From: Sarah Burrow <Sarah.Burrow@arun.gov.uk>
Sent: 26 November 2019 14:20
To: Daniel Vick <Daniel.Vick@arun.gov.uk>
Cc: Planning.Responses <Planning.Responses@arun.gov.uk>
Subject: RE: Clifton Road,Bognor Regis,West Sussex- Surface Drainage - BR/204/189/DOC

I am assuming that this application and calculations are for ONE soakaway for the FOUR houses in the terrace. If the application is for one house, or for four soakaways (one per house) then please disregard my comments and I shall reassess the application.

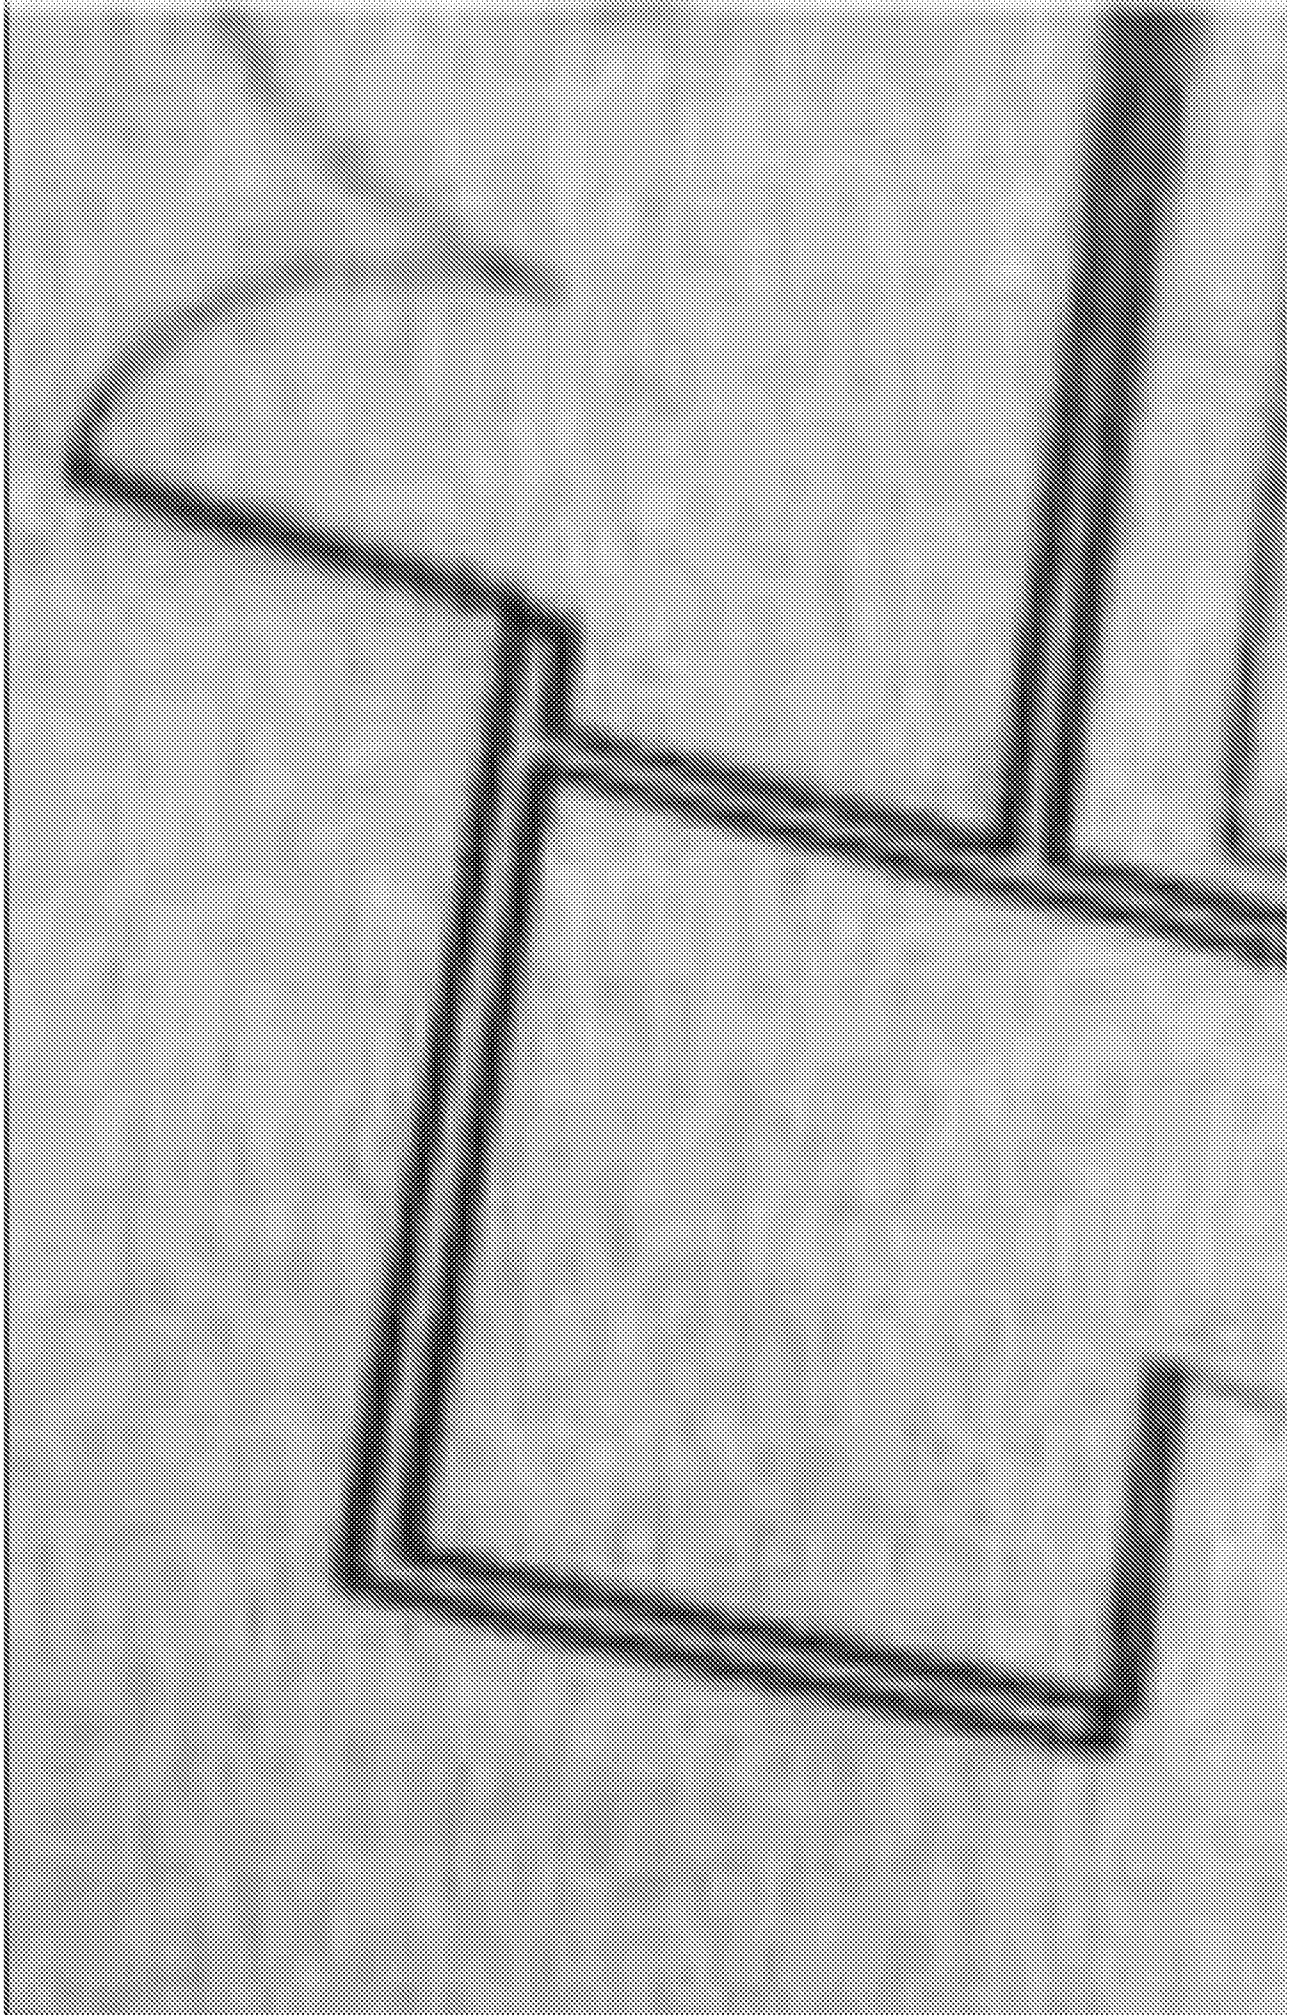
surface has been discharged into new soakaway, not into existing.

The two existing soakaways were dug out and mass filled with concrete.

Please see attached photos from our ground worker Glen Oakley. All approved by building control etc.
